From: [Pham, Minh](#)
To: ["planning.act@au.knightfrank.com"](mailto:planning.act@au.knightfrank.com)
Cc: [Cilliers, George](#); [Gell, Chris](#)
Subject: DA-201835109 - Block 21 Section 30 Dickson [SEC=UNCLASSIFIED]
Date: Friday, 21 December 2018 4:08:00 PM

From: [Brown, Ray](#)
To: ["Aaron Oshyer"](#)
Subject: Summary of Comments from referral entities - DA 201835109 - Block 21 Section 30 Dickson
Date: Thursday, 14 March 2019 5:47:00 PM
Attachments: [Not Approved Electricity174591.pdf](#)
[22012019085326-0001.pdf](#)
[ACTESA Response.pdf](#)
[Conditional Acceptance174602.pdf](#)

Application No: 174591 **Suburb:** Dickson

GROUND LEVEL PAVING PLAN

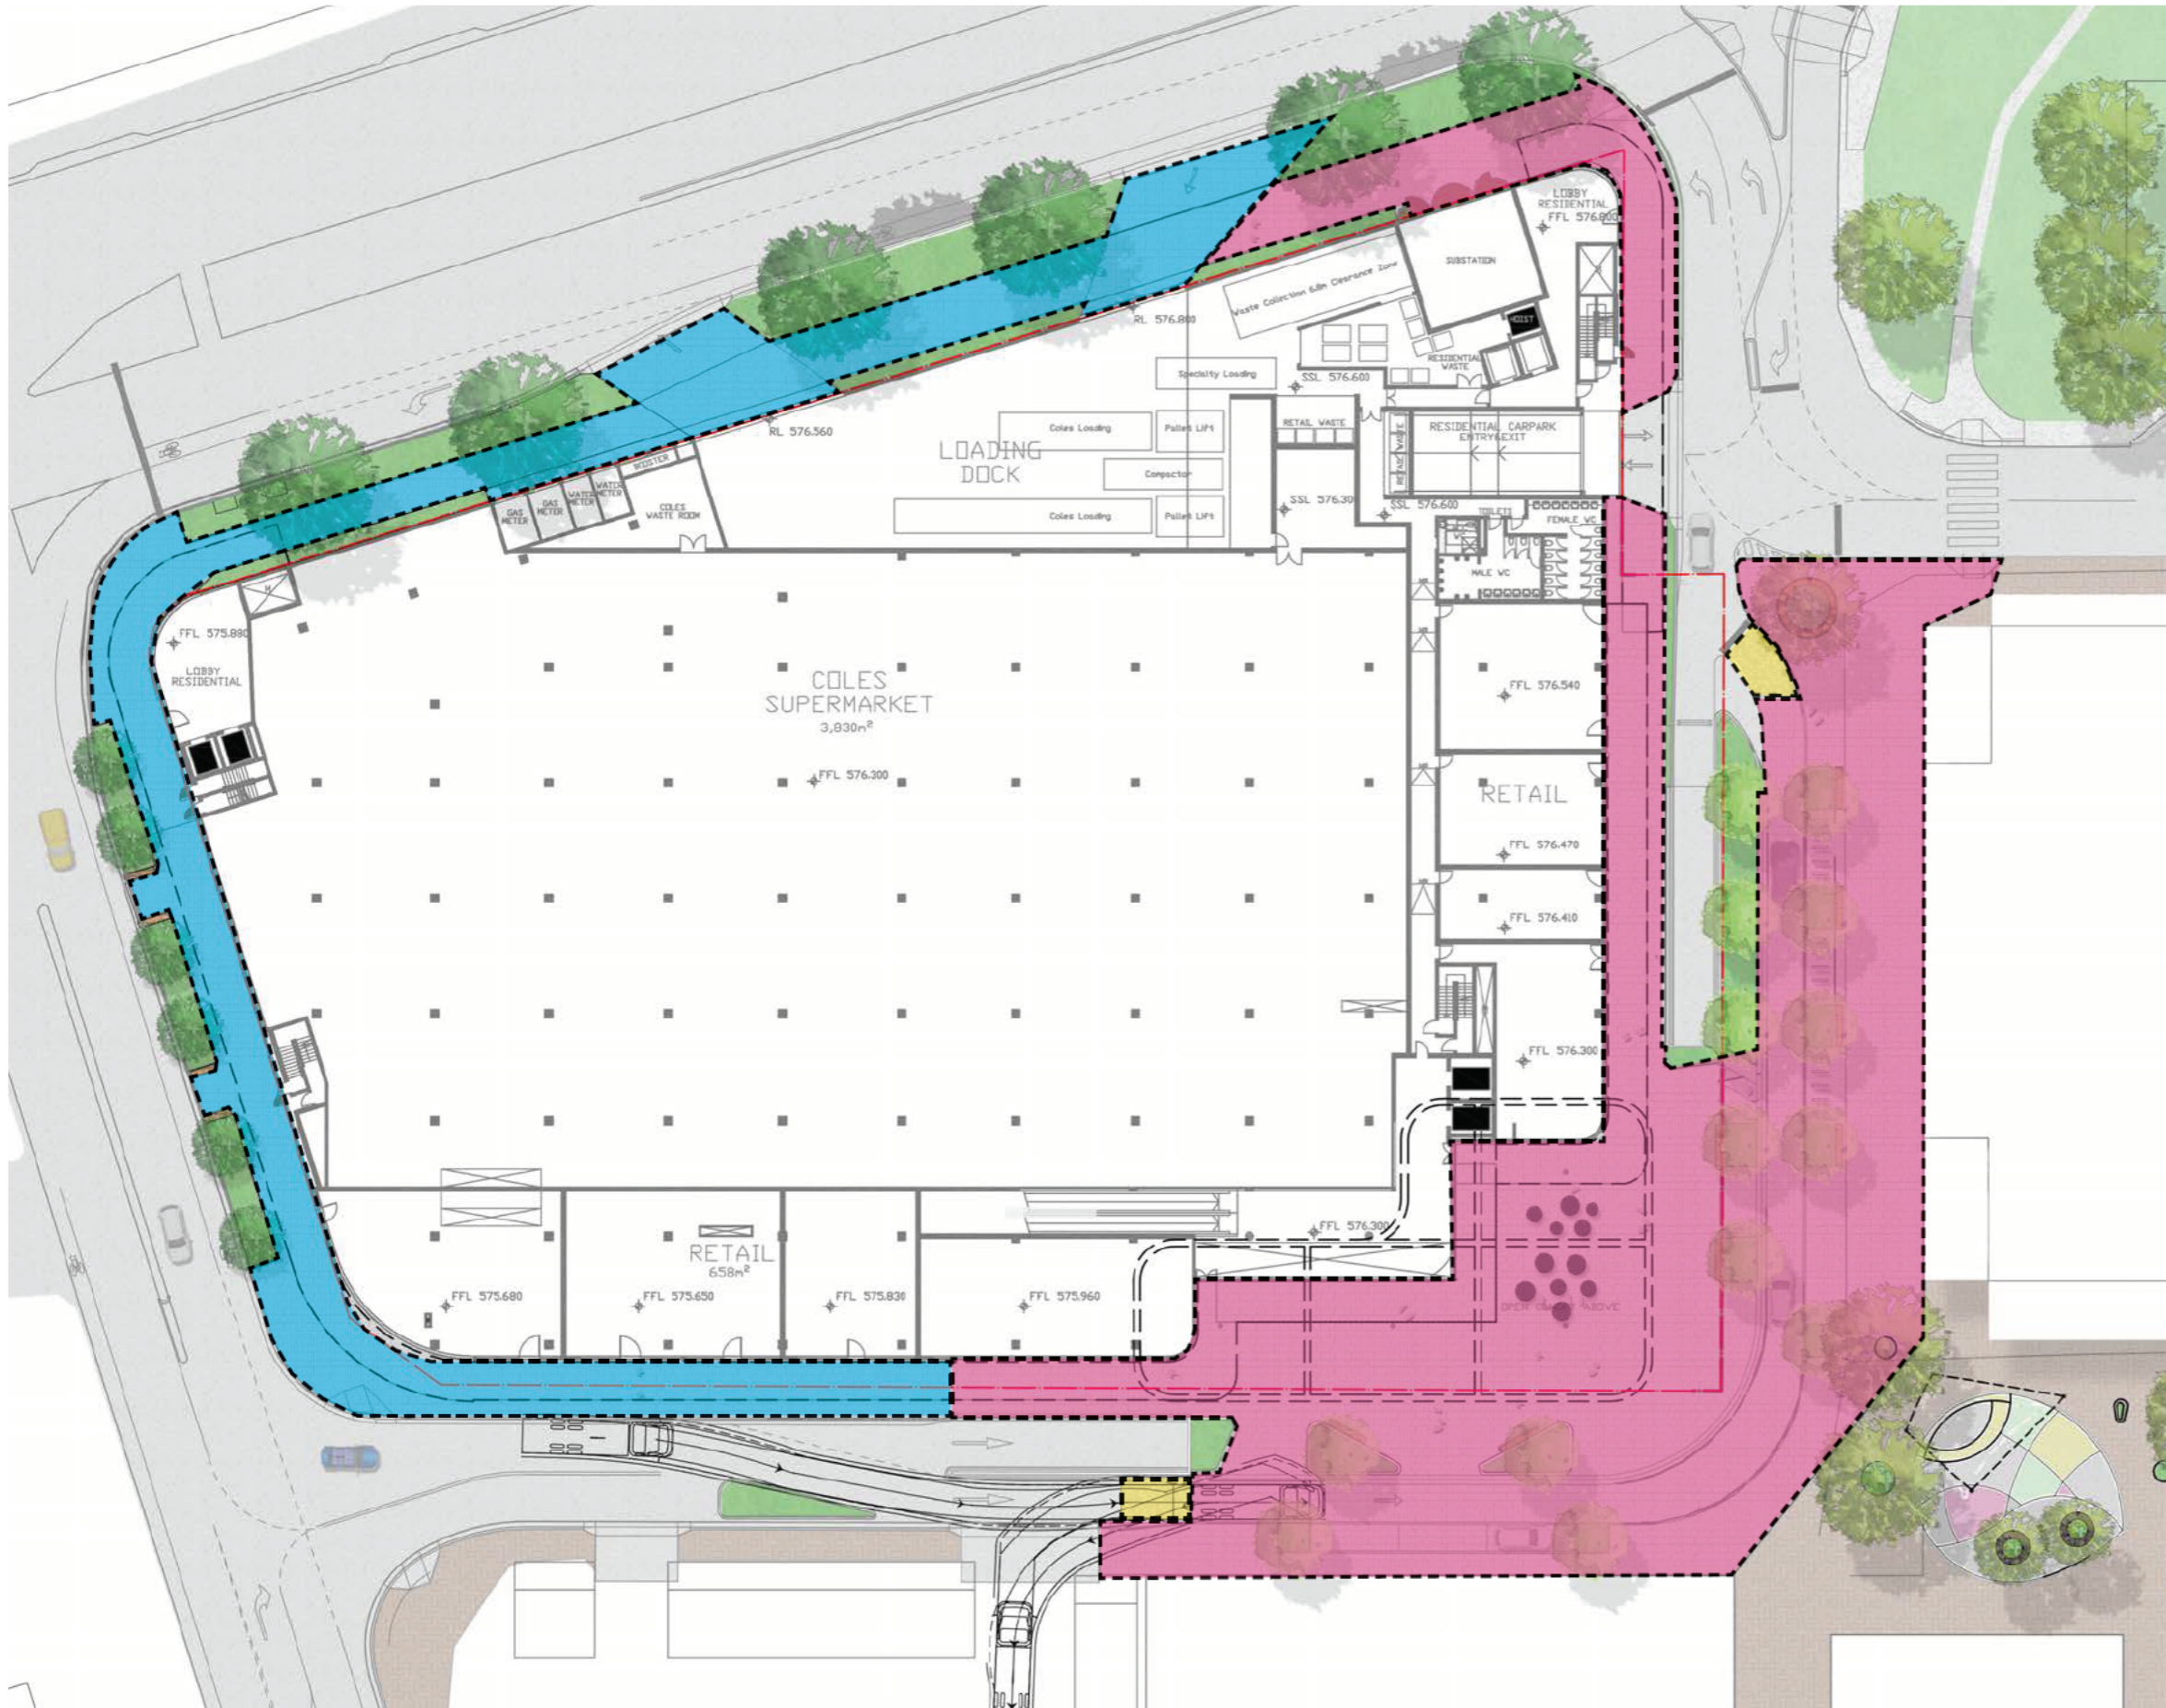
Thank you for a very informative meeting on 201835109-21/30 Dickson-01 yesterday. As discussed, Strategic Planning recommends that the proposed development uses paving which is the same/as similar as possible to the existing brick paving used in the Dickson group centre and particularly Dickson Square in front of the library. This paving should be used for the entire perimeter of the development. Using the same paving will link the proposed development to the centre. In addition the dark coloured paving currently proposed would contribute to heat island effect.
